DEVELOPMENT REVIEW COMMITTEE (DRC) COMMENT REPORT

PROJECT NAME: Sherwin Williams on NE 4th Ave

CASE NUMBER: ZR19003

REQUEST: Density (RD-15) District to Parking Lot (X-P)

Existing Stormwater Asset Map possibly affected by the Proposed Development

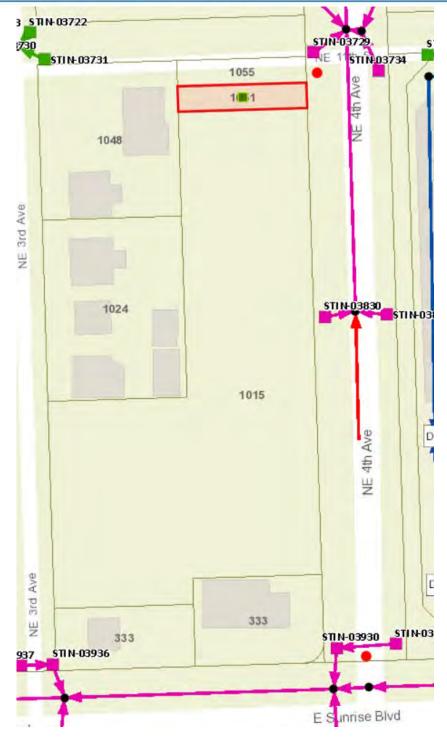
- 32. Conceptual Paving, Grading, and Drainage:
 - a. Provide sufficient existing and proposed grades and information on conceptual Paving, Grading, and Drainage Plan and details to demonstrate how stormwater runoff will remain onsite (include typical cross-sections along all property lines as appropriate, typical lot grading for the proposed single family homes within the development, and depict how the new stormwater system will connect to the existing on-site drainage system), and how the proposed project improvements (i.e. on-street parking, sidewalks, etc.) will not adversely impact the adjacent Right-of-Way, properties and waterways. Show location of building roof drains, and their proposed connection(s) to the on-site drainage system. Label existing City storm manholes/inlets using the labels provided in the figure at the end of these notes.

- b. Drainage mitigation shall be required for any impacts within the adjacent City Right-of-Way such as increased runoff or reduction of existing storage/treatment due to proposed improvements, in accordance with the City of Fort Lauderdale Comprehensive Plan (Ordinance C-15-08), Objective 4.1 under Infrastructure Elements. Engineer of Record (EOR) shall evaluate the adjacent City roadway system capacity and demonstrate that the proposed improvements will not negatively impact the City's existing drainage system and provide recommendations in compliance with the City's Comprehensive Plan (i.e. meets or exceeds the 10-year/1-day storm event drainage criteria). Applicant shall be responsible for maintenance of these proposed storm drain infrastructure improvements located within City Right-of-Way during a 1-year warranty period, until accepted by the City's Public Works Department. (coordinate as appropriate with the respective FDOT and BCHCED agencies for mitigation of additional runoff within those jurisdictions).

- c. Please note that private stormwater infrastructure (drainage pipes, wells, or basins,), Trees, or Permanent Structures (fences, walls, etc) are not permitted in City Right of Way or City drainage easements. Please remove any proposed stormwater systems, trees, or permanent structures that are not in compliance with this requirement or provide appropriate documentation of City Rights-of-Way or easement vacated to allow the construction of private underground utilities.
